# UNITED STATES PATENT AND TRADEMARK OFFICE

10/598,728

Harri Juntunen

<b>Office Action Summary</b>	<b>Application No.</b> 10/598,728	<b>Applicant(s)</b> JUNTUNEN, HARRI	
	<b>Examiner</b> Jeffrey O'Brien	<b>Art Unit</b> 3677

annotated  
FIG. 1

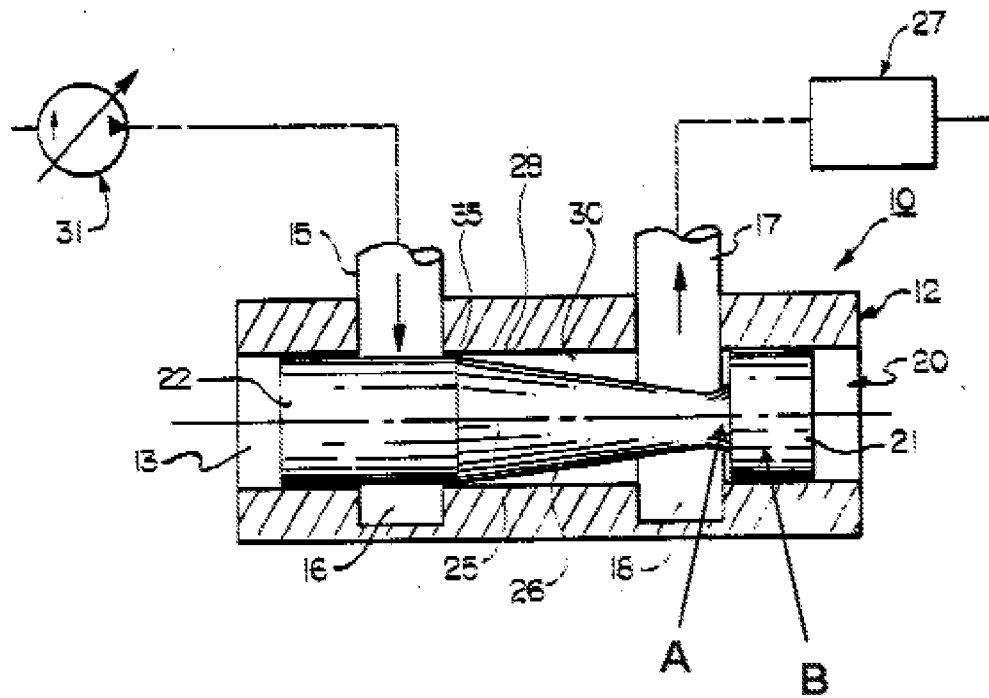
7. '919 teaches a valve having a beveled end (Fig. 1: 26) of a control part and at the beveled end of the control part, a support part (annotated Fig. 1: A) and a collar (B) that is a resilient material (wherein '919 is silent as to the material, but wherein bearings or collars are typically metal or plastic, both of which have some amount of resiliency) and can be placed around the support part (A) for providing a supporting surface that can be place against the housing body. It would have been obvious to one of ordinary skill in the art at the time of the invention to apply the support part and collar of the valve of

'919 to the valve of APA in order to allow for a close sliding relationship with the inner wall of the door closer body.
